Response to U.S. EPR Design Certification Application RAI No. 339, Supplement 7

Request for Additional Information No. 349, Supplement 7

U. S. EPR Standard Design Certification

**QUESTIONS for PRA Licensing, Operations Support and Maintenance Branch 2
(ESBWR/ABWR Projects) (SPLB)**

Figure 19-332-1—Phase diagram ZrO_2 -MgO

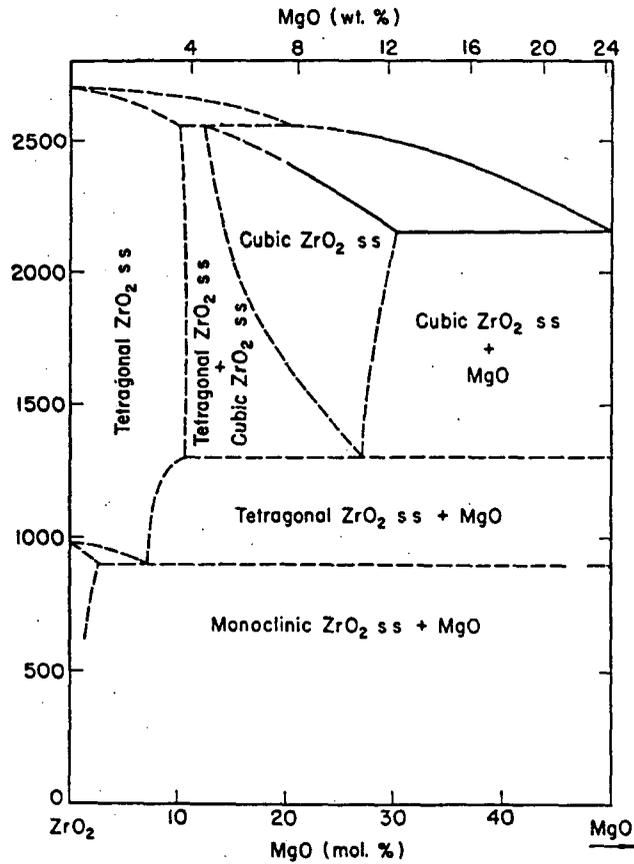
- a) The information provided on the material characteristics of the stabilized ZrO_2 does not include the solidus temperature of the U.S. EPR-specific MgO-stabilized Zirconia. Please provide the solidus temperature of Zettral 95GR that is planned to be installed in the U.S. EPR reactor pit.

A "solidus temperature" of zirconia Zettral 95GR is not a relevant parameter for the application. The main "impurity" in Zettral 95GR is MgO , with a concentration of 4 wt% or 11.4 mol% MgO . It is used to partially stabilize the cubic ZrO_2 modification. The phase diagram of ZrO_2 - MgO in Figure 19-332-1 shows that the solidus temperature at 11 to 12 mol% MgO is above 2500°C . Other oxides are present in a minimal concentration, and do not exist as separate oxides but form high-melting compounds such as fosterite ($2MgO \cdot SiO_2$) or spinel phases.

Figure 19-332-5—Oxygen Solubility in an Iron/Chromium Melt

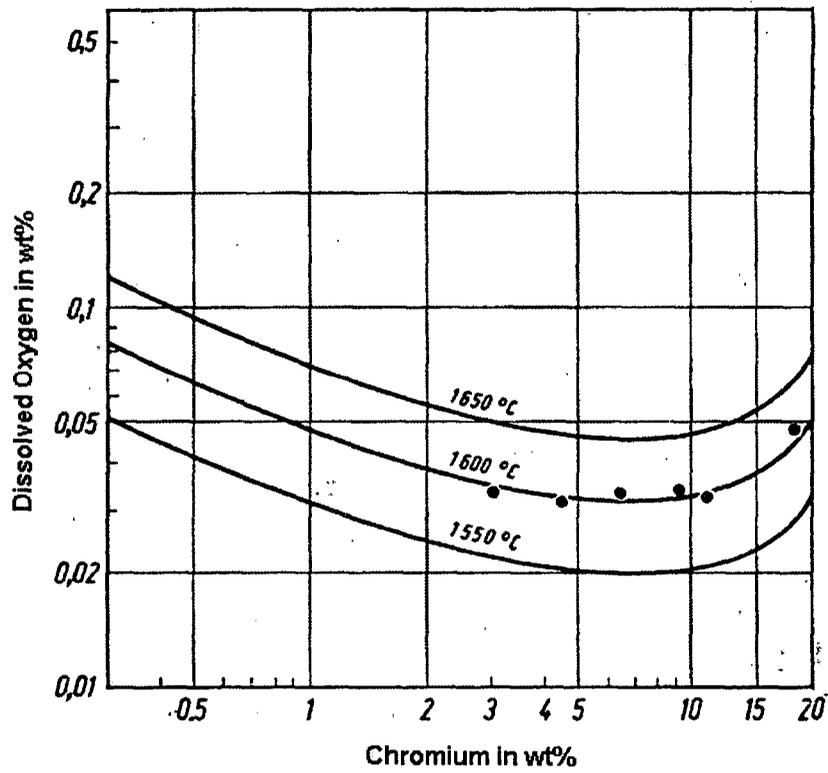
- b) The MgO-stabilized ZrO_2 -tested for compatibility with metallic melts was found to be stable to 2200°C for duration of six hours under relatively oxygen-free melt condition. However, it was mentioned that melt infiltration (but no significant thinning) of the ceramics was observed for oxygen contents higher than postulated for U.S. EPR severe accident melts. Please provide justification by presenting available experimental evidence on the compatibility of U.S. EPR specific zirconia (or similar zirconia) with metallic melts having oxygen contents in the range expected for severe accidents in the U.S. EPR.

The addition of iron oxide to the top slag of a steel melt leads to partial reduction of FeO to Fe and oxidation of Cr to Cr_2O_3 . Reference 2 and Reference 3, which discuss metallurgy, show that FeO and Cr may coexist. For example, Figure 19-332-5 shows that 0.03-0.04 w% oxygen can be dissolved in a Fe/2-15 w% Cr melt at 1600°C. This oxygen amount is stable against Cr and is not oxidized to Cr_2O_3 .

Figure 19-332-22—Measured Melt Temperatures in MACE 3b

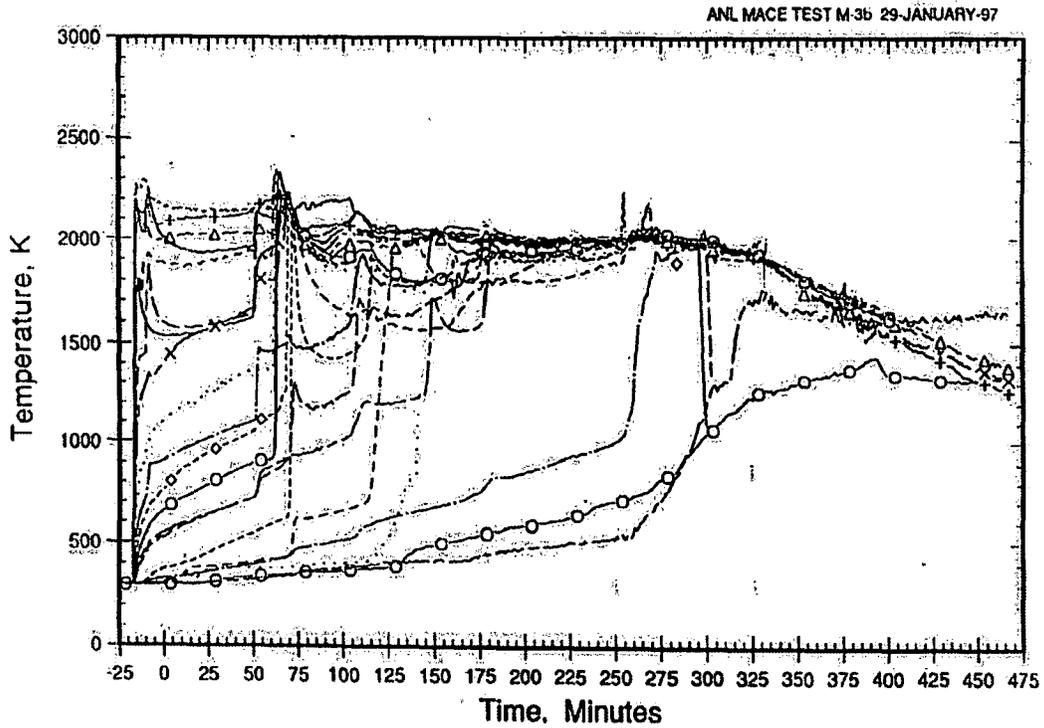
- d) A summary of experiments on the interaction of oxidic melts with ZrO_2 , including Zettral 95 GR sample materials (not bricks) under MCCI conditions are stated to show that the zirconia samples survived with minimal attack because, it is asserted, the MCCI causes the addition of low-melting concrete decomposition products into the corium melt, thus keeping the melt temperature below the liquidus, and causes the melt to be saturated with zirconia. The interaction time between the melt and the ZrO_2 varied from 5 to 15 minutes for the four experiments. This time range is small compared with the estimated time of 3 hours for retention of the melt in the reactor pit. Reference is also made to the MACE experiments. Please provide experimental evidence (e.g., AREVA, MACE, etc.) on the time evolution of melt temperatures during sustained tests, including MCCI, supporting the compatibility oxidic melts with Zirconia.

Sample temperature plots from MACE tests M3b and M4 are shown in Figures 19-332-22 and 19-332-23.

Figure 19-333-1—MAAP Analysis of Ru Release Fraction During Air Ingression

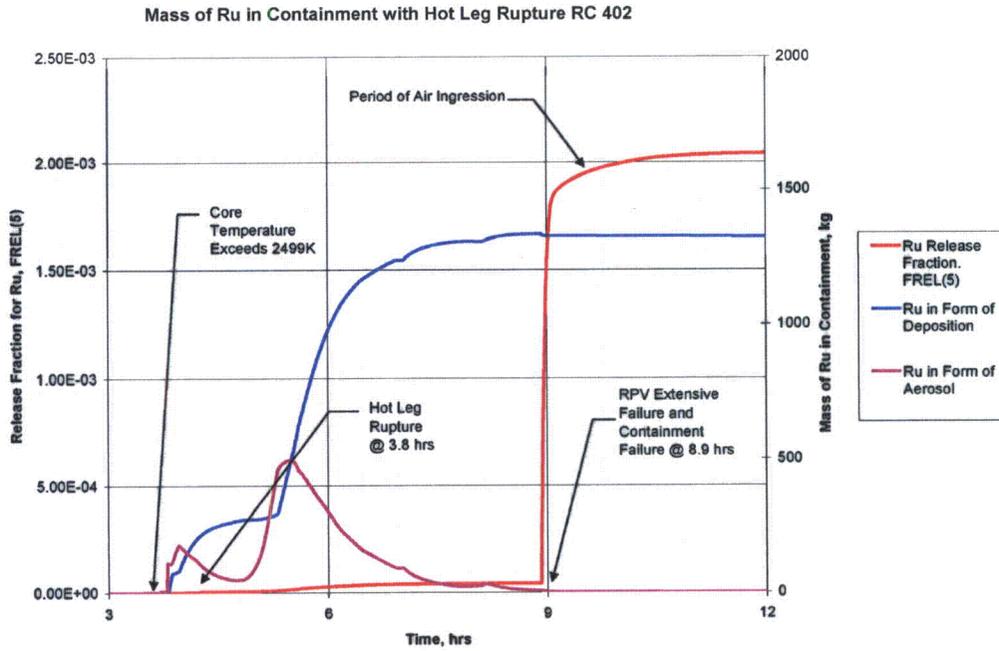
The response to Question 19-158 is, for the most part, satisfactory. However, it does not address the risk implications of enhanced Ru release, especially, relative to the early and latent fatality safety goals. Please include a discussion on air ingress and enhanced release of Ru in the FSAR. In addition, please provide sensitivity calculations on the potential impact of increased Ru releases on the early and latent fatalities, and discuss impacts on the U.S. EPR SAMDA evaluation.

Results from the modular accident analysis program (MAAP) analyses of the accident release scenarios show increases in the release fraction group containing Ru following the establishment of an air ingress pathway. Figure 19-333-1 is a U.S. EPR release scenario that demonstrates a period of increased Ru formation. During these periods of air ingress, the chemical equilibrium and mass transport models within MAAP simulate the generation, transformation, and transport of the formation of the Ru through the accident analysis. Ru contained within the core is model in its elemental form and is treated as RuO₂ in the release fraction FREL(5). The release dynamics for Ru are dominated by oxygen concentration, fuel surface area, and fuel temperature, of which MAAP's predictive capability is applicable. The effect of Ru during air ingress accident scenarios is captured in the release fraction results generated with MAAP. Further oxidation of RuO₂ into the highly volatile RuO₄ species is not modeled by MAAP.
